**Appendix C-A: Nuttli's Letter  
(January 24, 1983)**

**Appendix C-B: Trifunac's Letter  
Regarding R  
(January 18, 1983)**

**Appendix C-C: Campbell's Letter  
Regarding R  
(January 1, 1983)**

### Questionnaire 5

Figure 1

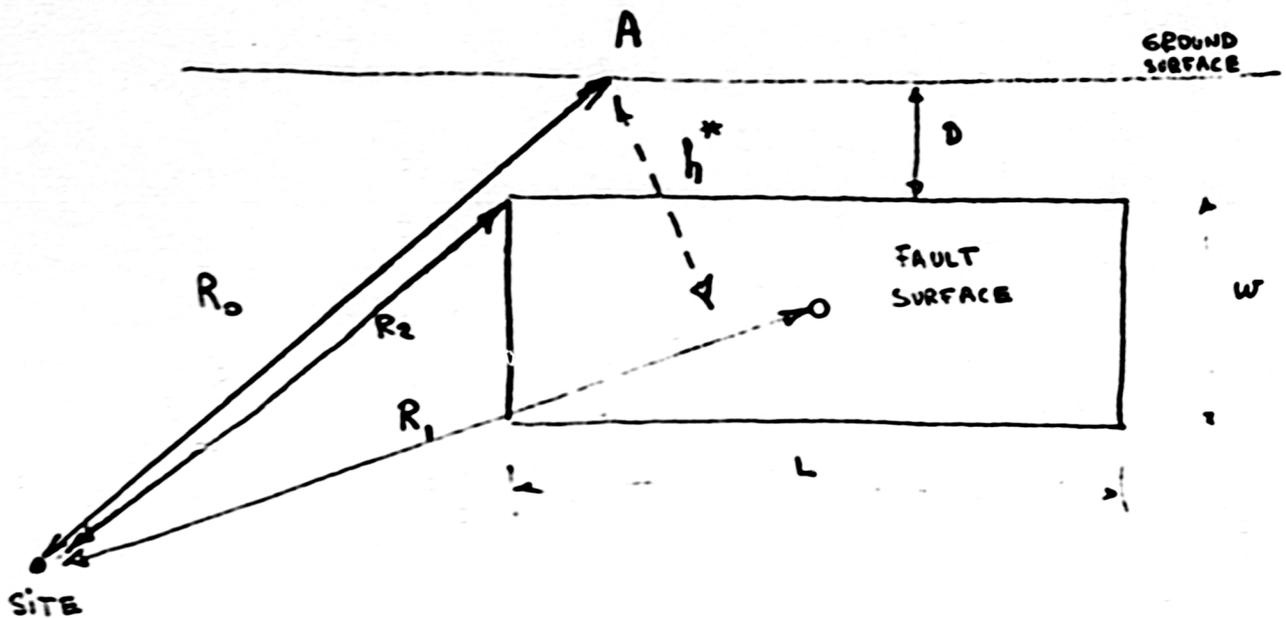
1. Joiner and Boore (1981) employ a definition of distance which is equivalent to  $(R_0^2 + h^{*2})^{1/2}$  in the enclosed Figure 1. In their work  $h^*$  is a 'measure' of the source depth selected to minimize the sum of the squares of the residuals. This definition of distance would be appropriate if an argument could be made that the peak ground motion comes from the portion of the fault surface which is at 'depth'  $h^*$  and beneath A in Figure 1.
2. Campbell (1981) uses distance  $R_2$  (in Figure 1) and a magnitude dependent 'coefficient'  $C(M)$  which physically resembles  $h^*$ . This is also fitted to the data to minimize the sum of the residuals squared.

BOORE & JOINER (1981) use  $r = (d^2 + h^2)^{1/2}$  where "d is the closest distance from the recording site to the surface projection of the fault rupture." This corresponds to  $R_0$  in Figure 1

Campbell (1981) uses "shortest distance between the station and the fault rupture surface"... I interpret this to correspond to distance like  $R_2$  in Figure 1

I would like to take this opportunity to respond to Dr. Trifunac's letter of January 18 regarding the use of "distance" in strong-motion scaling relationships. He claims that the use of shortest distance between the recording site and the fault rupture surface (used by Campbell, 1981) has a tendency to underestimate peak amplitudes of strong ground motion for small distances. He infers from his Figure 2 that this could be avoided by defining distance as the distance from the recording site to the center of the fault surface. This latter definition is preferred by Dr. Trifunac, since it is not known in advance which part of the fault will contribute most to peak ground motions.

Although we may not know in advance where the peak motions will come from, there is considerable evidence to suggest that closest distance to the fault rupture ( $R_2$ ) is a more appropriate measure than distance to the center of fault rupture ( $R_1$ ) for characterizing and predicting the scaling properties of strong-motion parameters. In fact, scaling relationships based on  $R_1$  as they are commonly used will lead to overestimation of peak parameters in some cases. Arguments in support of these statements are as follows:

Figure 2

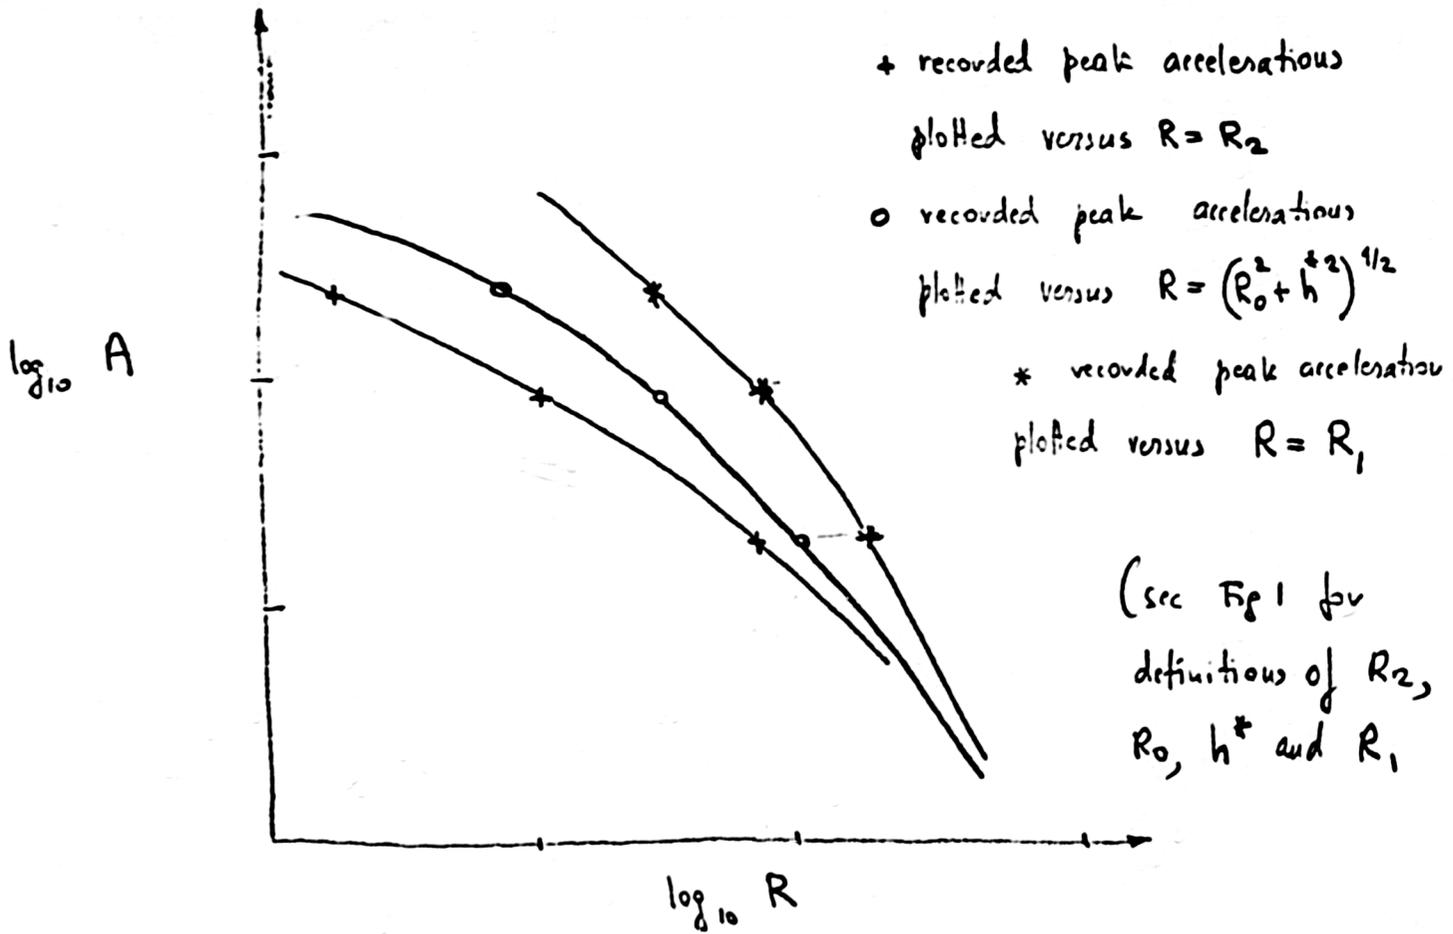
Assume we have recorded three peak accelerations and we wish to plot those versus same distance  $R$  as in Figure 2. In a typical case (say Imperial Valley 1979 data) I interpret Campbell's work to plot these data points as crosses (+) in Figure 2. Joiner and Boore (1981) definition would lead to the peaks plotted as circles (o) in Figure 2 (assuming that somehow we know  $h^*$ ). Assuming on the other hand, that we wish to plot those peak accelerations versus distance  $R_1$ , which is a distance to a 'center' of the fault surface we would get the points shown by asterisks, (Figure 2). It is obvious from the geometry of Figure 2 that  $R_0 < R_1$ ,  $R_2 < R_1$  and  $(R_0^2 + h^{*2})^{1/2} < R_1$ . Since we do not know a priori which part of the fault will contribute most to the peak ground motions, unless  $L \gg R_1$  it would seem reasonable to use some definition (in the mean) close to  $R_1$ . This effect is of course significant only for small  $R_1$  and as  $R_1 \rightarrow \infty$  all definitions of distance become indistinguishable. Therefore I believe that Joiner and Boore (1981) as well as Campbell (1981) have a tendency to underestimate peak amplitudes of ground motion for small  $R$ . This is seen from sketch in Figure 2.
